Product Safety Recall

YAMAHA TMAX Motorcycle Main Stand Breakage

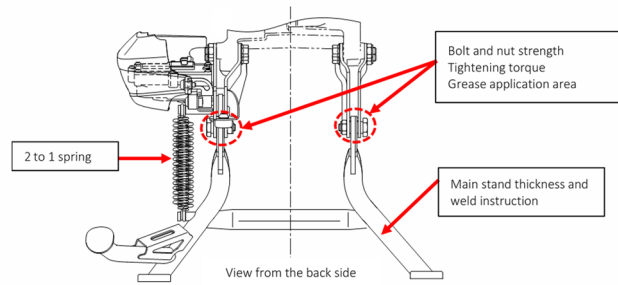
The strength of the XP530A main stand may be compromised due to substandard welding at the cross tube.

Repeated operations of the main stand may cause cracking at the weld areas and possible breakage. If the stand was to break and the bike was to fall over, it could cause serious injury to the rider or bystanders.

To correct this defect, Yamaha is initiating a Factory Modification Campaign, whereby affected XP530A models must have the main stand replaced with one that has been strengthened by increasing the tube thickness and modifying the welding process.
